STREAMLINED REMEDIATION SYSTEM EVALUATION (RSE-LITE)

CAPE FEAR WOOD PRESERVING SITE
FAYETTEVILLE, NORTH CAROLINA

Report of the Streamlined Remediation System Evaluation
Conference Call Conducted
August 5, 2004

EPA 542-R-05-005
February 2005
www.epa.gov/tio
clu-in.org/optimization

FIGURE 1-3. SITE LAYOUT WITH WELL LOCATIONS.

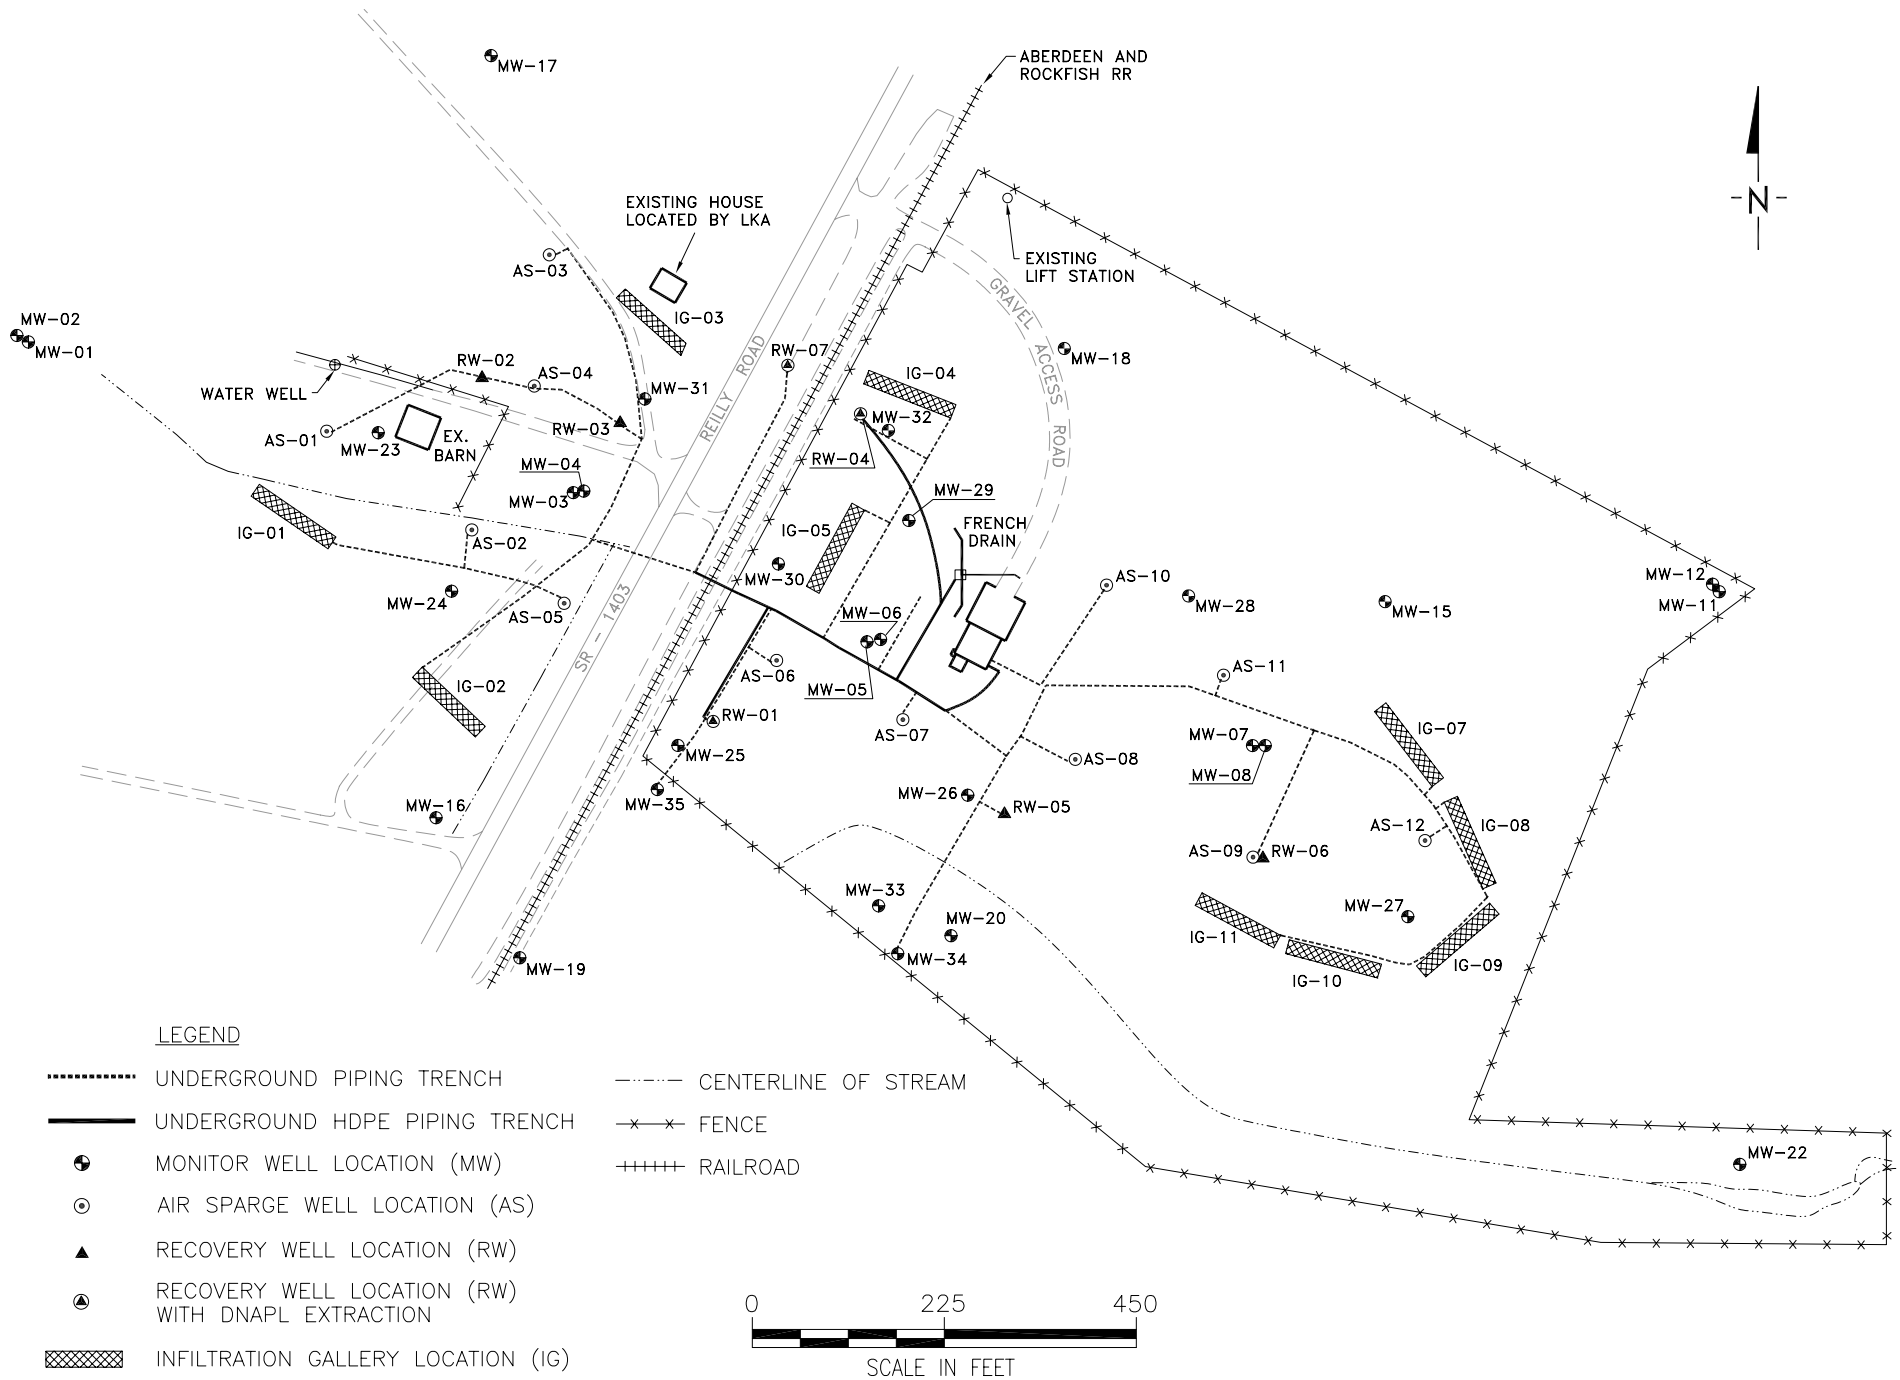
The locations of the french drain, seven recovery wells, and ten infiltration galleries are depicted in Figure 1-3. The recovery wells and the french drain are constructed with polyvinyl chloride (PVC) and are completed in the upper aquifer at depths of approximately 25 to 30 feet bgs. The recovery wells are outfitted with pneumatic submersible pumps, each with a capacity of 9 gpm, and the french drain is outfitted with a double diaphragm pump with a capacity of 15 gpm. RW-1, RW-4, and RW-7 also have bladder pumps for DNAPL recovery. All of the recovery wells have a 6-inch diameter, with the exception of RW-5, which has a 4-inch diameter. Each infiltration gallery is 100 feet long. Piping that conveys extracted ground water to the treatment system and treated water to the infiltration galleries is constructed with schedule 80 PVC. Piping that conveys recovered DNAPL to the DNAPL storage tanks is constructed with high density polyethylene (HDPE). The locations of the air sparge points are also indicated on Figure 1-3. Each of the sparge wells has a 2-inch diameter.

Water levels from monitoring wells are measured monthly. These data and the data from operating recovery wells and infiltration galleries are used to generate potentiometric surface maps monthly. However, water levels from operating recovery wells and infiltration galleries should generally not be used in developing potentiometric surface maps. Due to well losses, the water levels from recovery wells generally over-emphasize the effect of pumping on the surrounding aquifer, and due to fouling, water levels from operating infiltration galleries generally over-emphasize the degree of mounding. For the Cape Fear site, the potentiometric surface maps appear particularly biased by the water levels from the operating recovery wells. Therefore, these potentiometric surface maps should not be used for evaluating plume capture.

- Exclude water level measurements from active recovery wells and infiltration galleries when generating potentiometric surface maps. The water level measurements should not be used to generate potentiometric surface maps due to well losses. Also, the potentiometric surface maps should be generated for both the upper and lower aquifers using the data from the corresponding aquifers.

FIGURE 1-5. EXTENT OF DISSOLVED GROUNDWATER CONTAMINATION BASED ON THE 4TH QUARTER 2003 SAMPLING RESULTS.

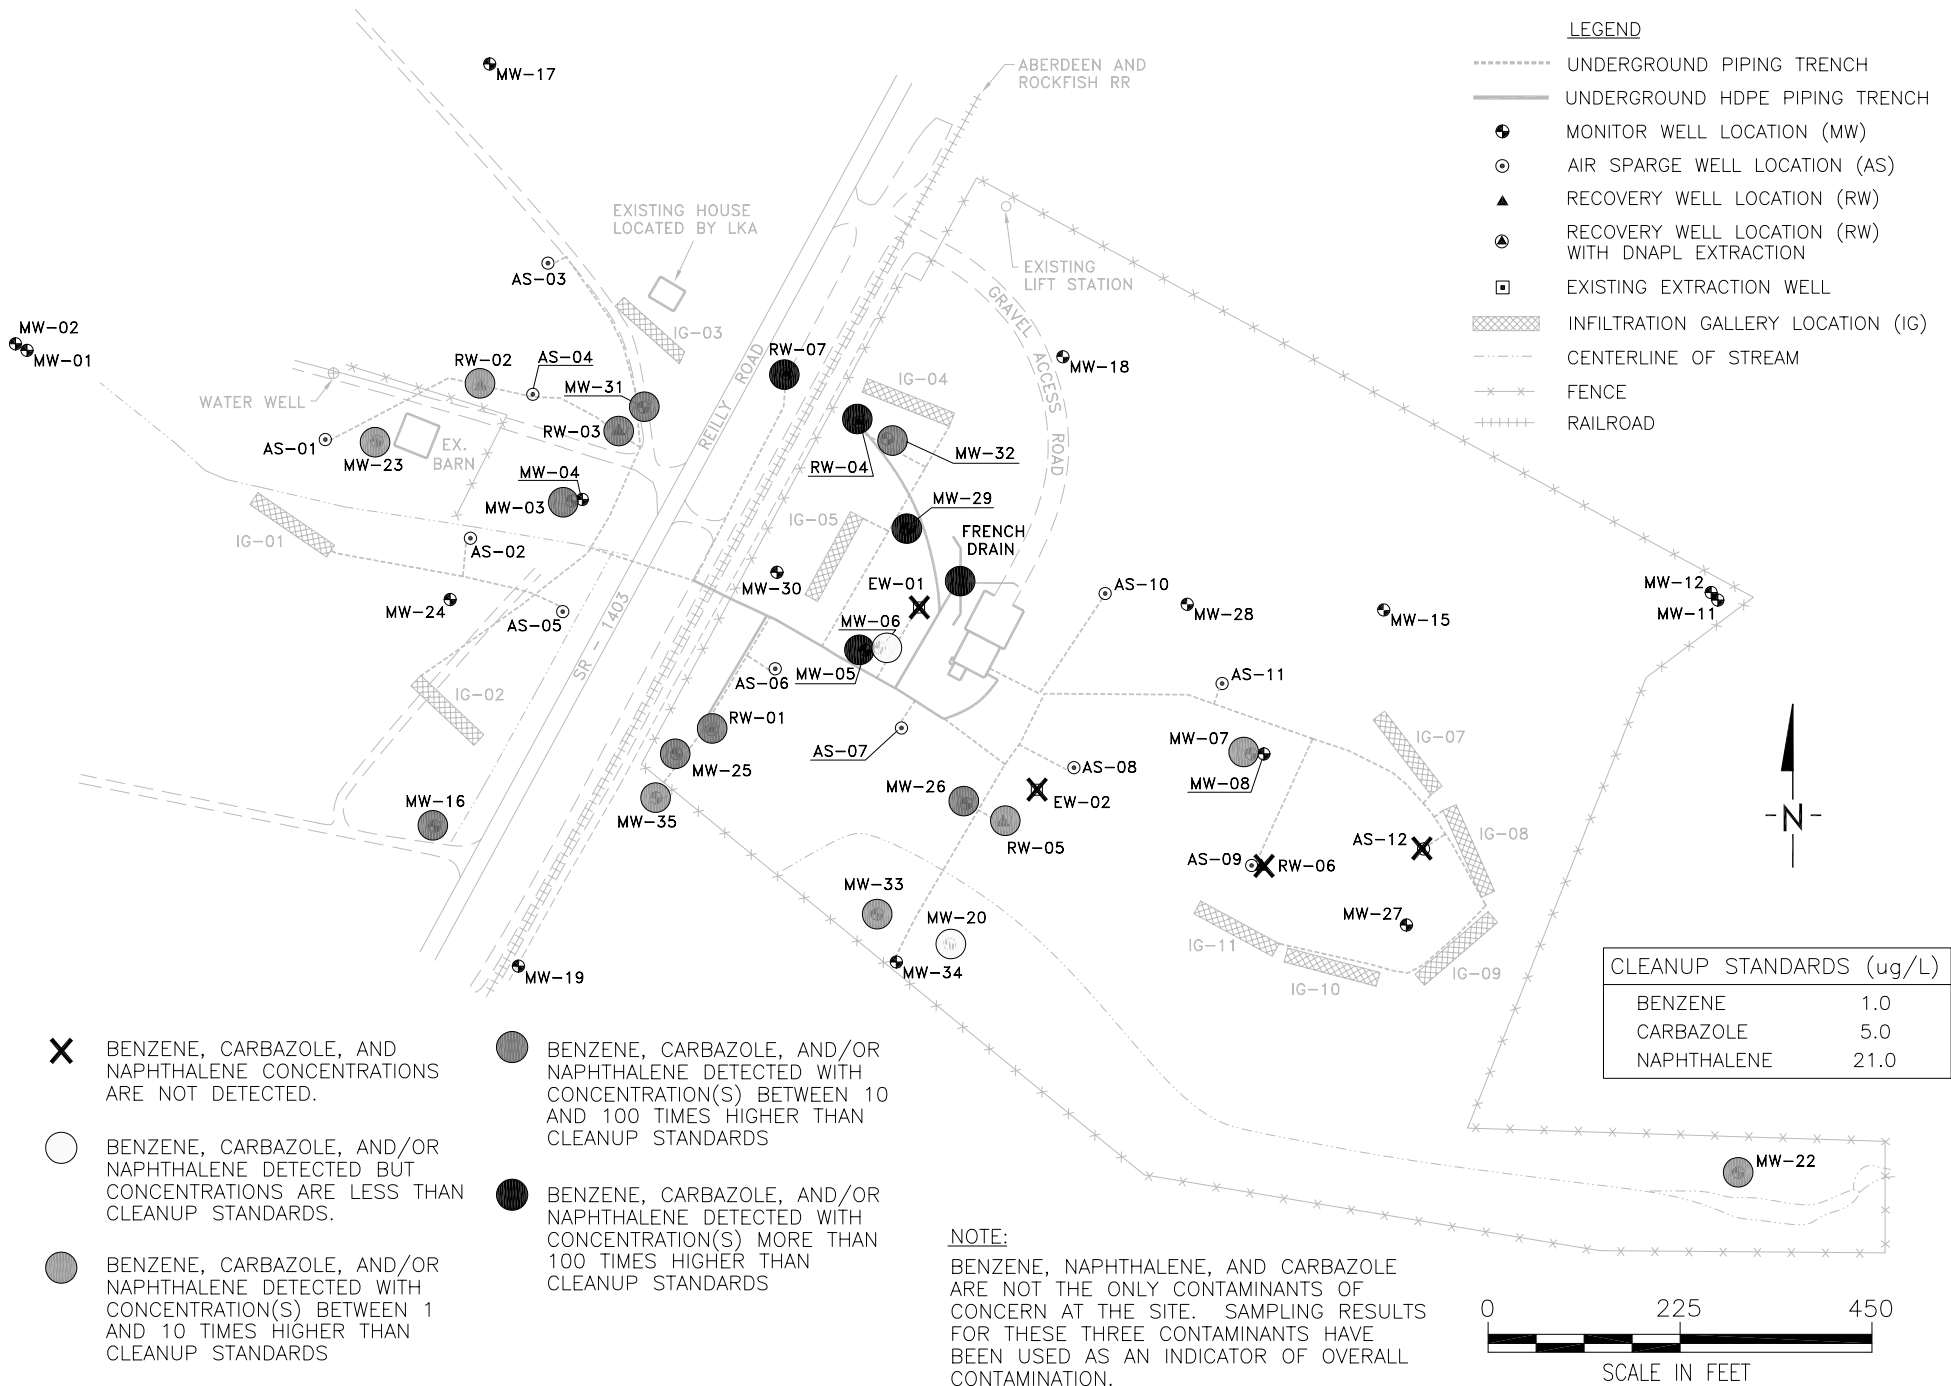
The extent of ground water contamination as determined by the 4th Quarter 2003 sampling event is illustrated in Figure 1-5. The figure indicates the magnitude of benzene, naphthalene, and/or carbazole concentrations at each sampling location compared to the cleanup standards. Although there are other contaminants of concern, these three contaminants are generally representative of the contaminant plume. All wells with sampling results depicted are from the upper aquifer with the exception of MW-3, MW-5, and MW-16, which are from the lower aquifer. The figure demonstrates that contamination has migrated approximately 500 feet to the west, southwest, and south from the historical source areas. Limited ground water contamination is also indicated at MW-07 and MW-22. The contamination at MW-07 may result from ground water transport, but the contamination at MW-22 is likely due to contamination that had historically migrated above ground via the drainage ditch rather than through the aquifer.

Based on the depicted sampling results, the plume is not delineated to the north or to the southwest near MW-16. The recent sampling shown in Figure 1-5 does not delineate the plume to the west; however, historical sampling at MW-1 and MW-2 from the baseline event delineates the plume to the west as of 2001.

Current monitoring is likely insufficient in some areas. For example, there is no monitoring well located downgradient (i.e., southwest) of MW-16, which screens the lower aquifer and has impacts that are at least 10 times greater than applicable standards. Although MW-19 is located south of MW-16, it has not been sampled recently, and it appears to be more downgradient of MW-35 than MW-16. Monitoring to the north is also limited. The highest contaminant concentrations at the site are in RW-7 and RW-4, and there is no consistent sampling north of these points. Therefore, additional data are required to determine if plume migration is being adequately prevented.

A monitoring well should be installed approximately 200 feet downgradient (i.e., southwest) of MW-16 and at the same depth as MW-16. MW-16 and this new well should be sampled and analyzed for VOCs to determine the extent of naphthalene and benzene migration beyond MW-16. This new well should also be added to the ground water monitoring program.
